# 1001 JOHN ST

SEATTLE WA, 98109  
DPD# 3020563

**WEST DESIGN REVIEW BOARD:**  
DESIGN RECOMMENDATION 2 MEETING  
JULY 13, 2016

Recommendation Response Comments Matrix

Previous section details

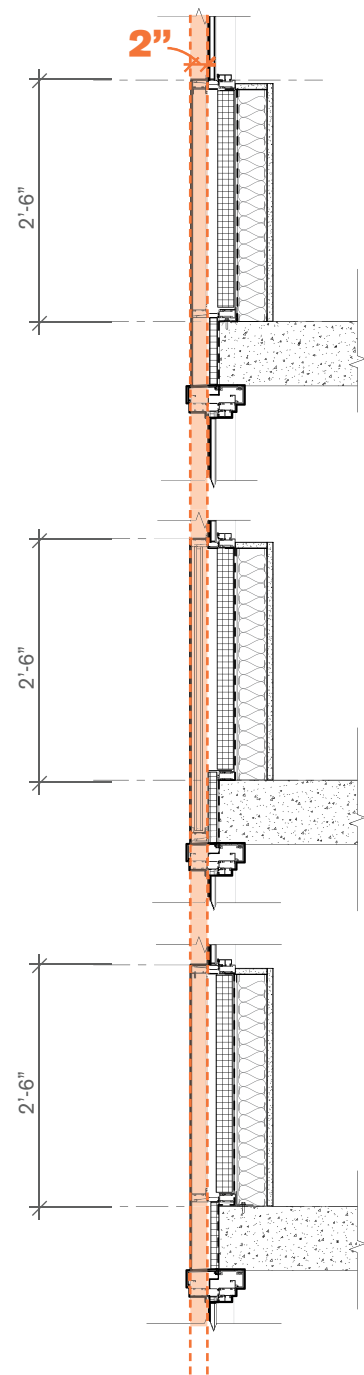
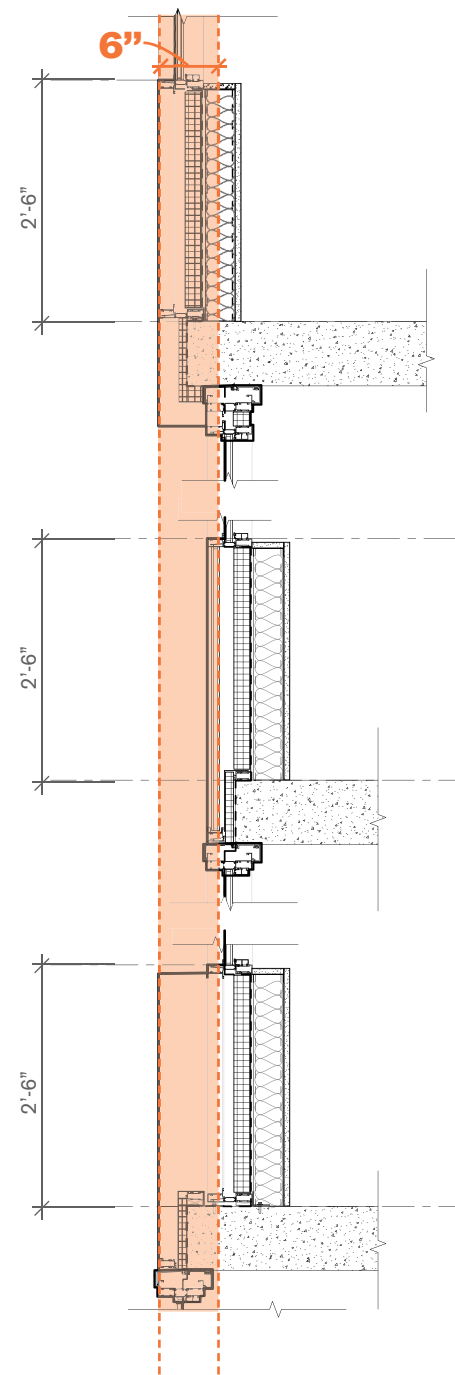
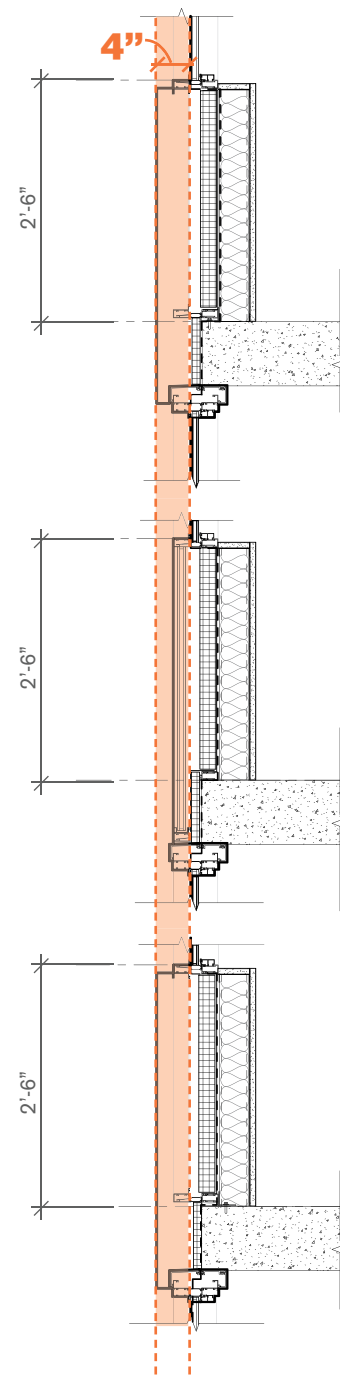
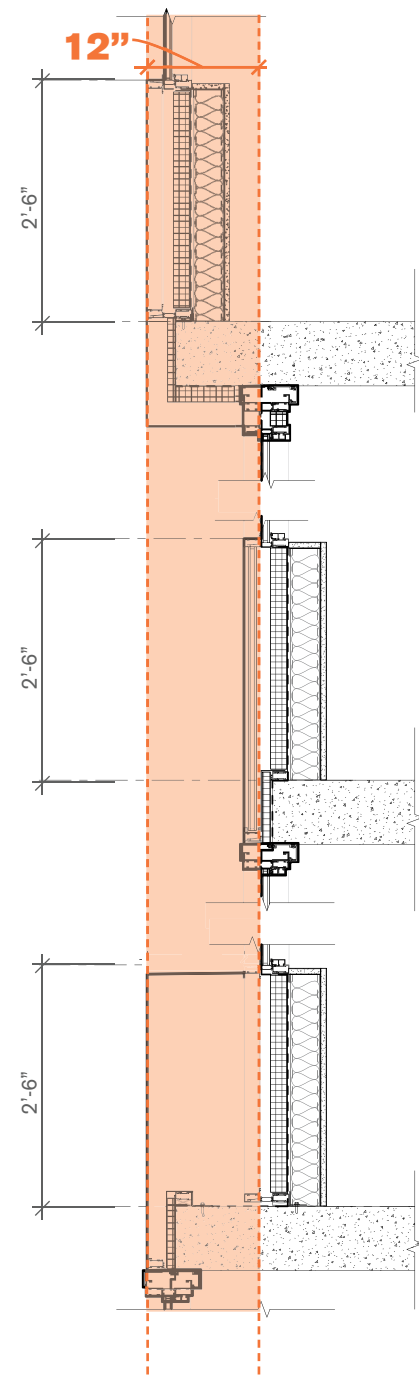
a. At the northeast corner and north façade, the Board agreed that the rhythm of four floors of glass and ‘white’ metal panels separated by two floor of vision and spandrel glass, should be emphasized by providing a 12” setback of the 2-story section so that it is clearly legible. (DC2.B.1)	At the previous DRB meeting the setback was 6” due to constructability and maintenance issues. The applicant will recess the 2- story section 12”. Along with the darker spandrel this will make the 2 story section visibly recess.

b. The Board was concern with the overall flatness of the tall and highly visible elevation and recommended that at the bronze metal facades, the vision and spandrel glass should be set back by 8” to create greater texture and depth to these elevations. (DC2.B.1)	The applicant had proposed a 2” recess between metal panel and face of glass in the typical window section. This amount of recess is more than the usual amount seen with many glass/metal panel buildings in the city. To meet the request of a deeper recess the applicant has worked with the window wall supplier, contractor and manufacturer to attain the maximum amount possible with the window-wall system which is 4”. The applicant is also using a darker window frame color to help add depth to the wall. The applicant will also be using a 2-coat “mica” metal finish to add further visual interest to the bronze panels.

NORTHWEST CORNER

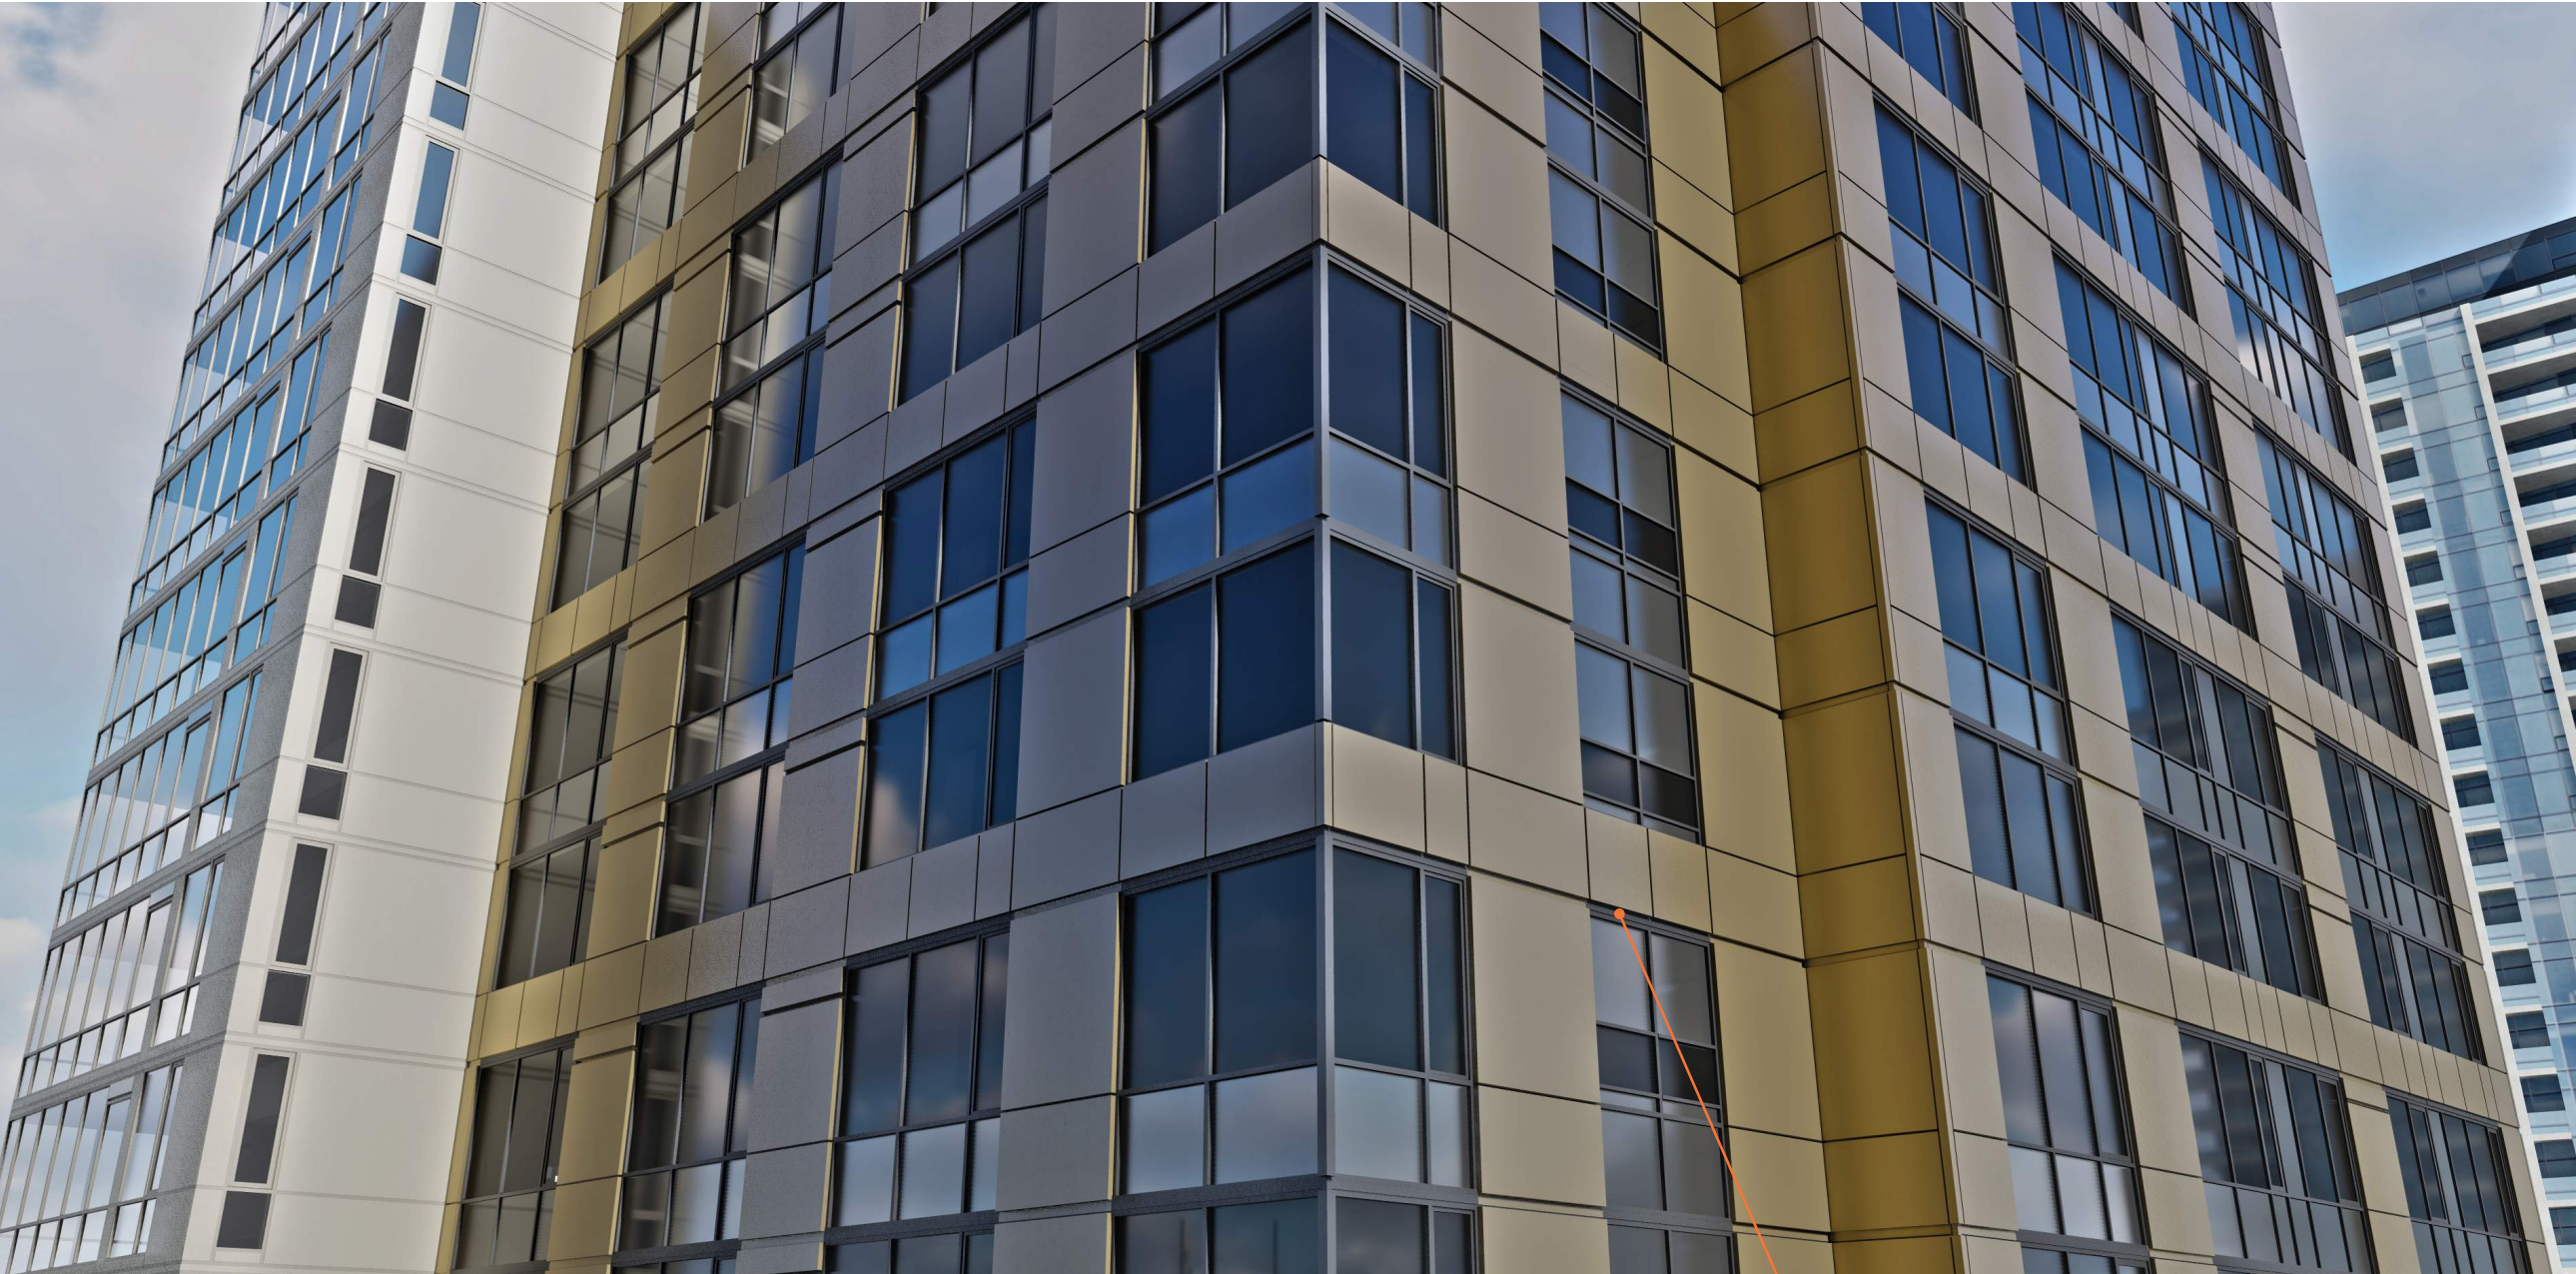
a 12" set-back

b 4" skin depth  
(maximum system capability)

SOUTHEAST CORNER

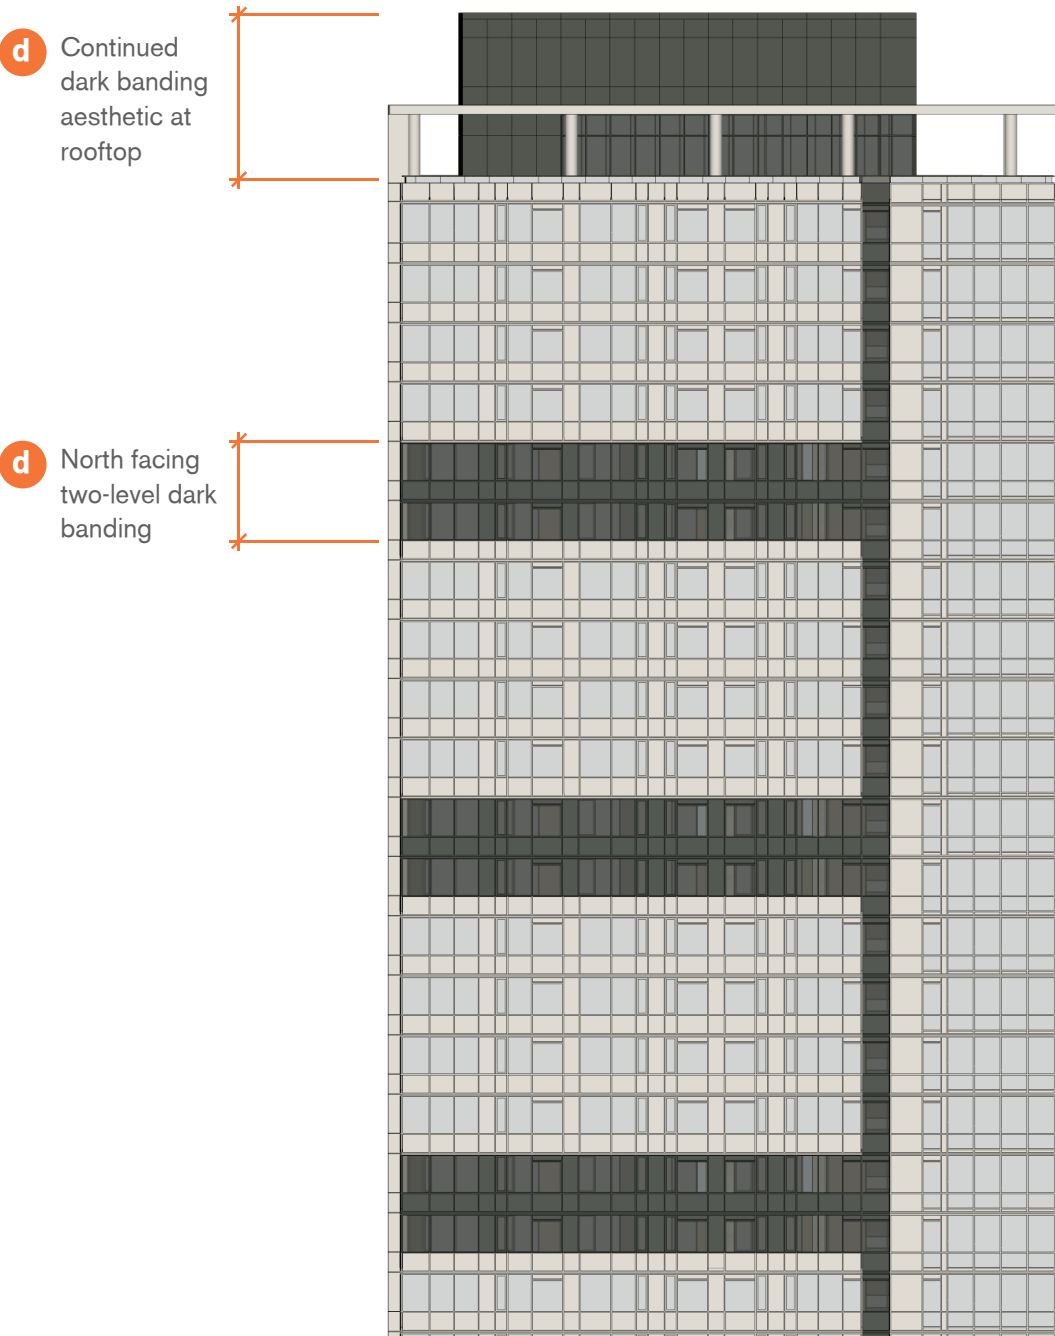
**b** 4" skin depth  
(maximum system capability)

**c** 24" fin depth

Section through screens

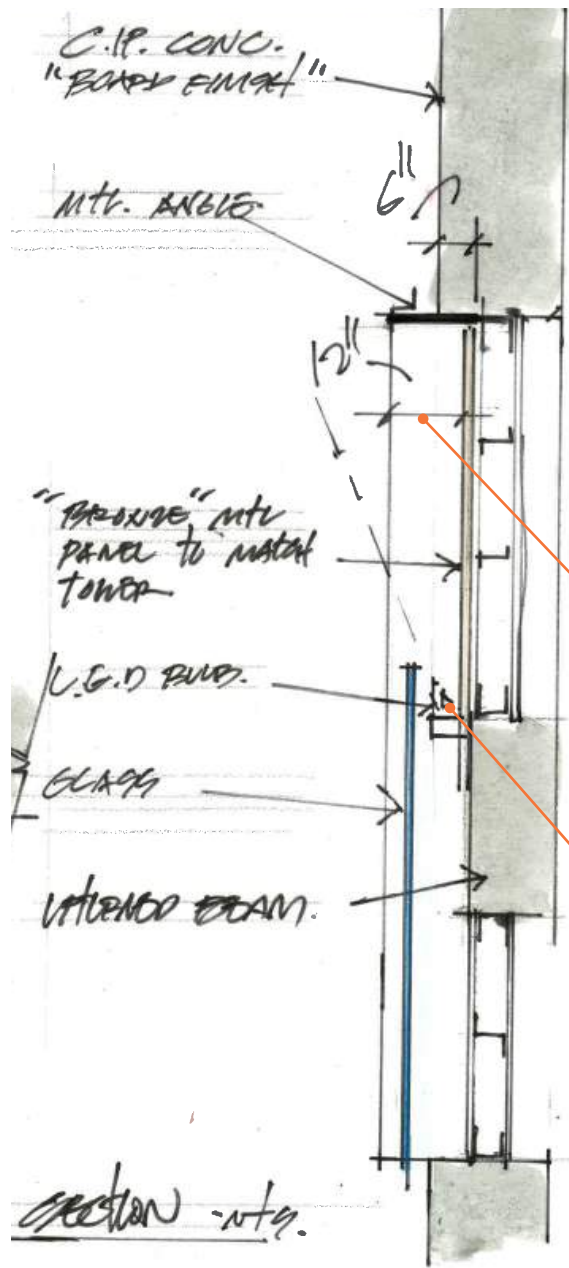
a b Screen section detail showing 12" max depth

c Accent lighting
